UCHealth – University of Colorado Hospital Parking Garage 2 Pedestrian Bridge

University of Colorado Design Review Board Schematic Design June 15, 2021

DRB Preliminary Feedback

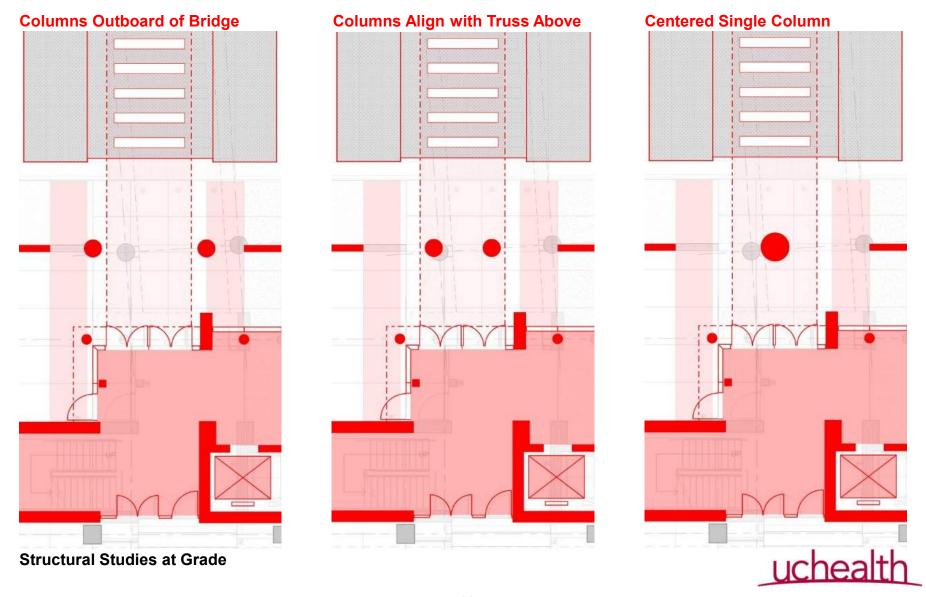
- What is the status of the Garage 2 Project?
- Is there an opportunity to look at the overall alignment of the bridge as it relates to the ACP entrance?
- Bridge structure?
- Can the overall bridge façade be level instead of following the slope of the bridge?
- How do the bridge mullions relate to the garage mullions and ACP mullions?
- What do the selected bridge materials/finishes relate to?
- What does the selected ceramic frit pattern relate to?
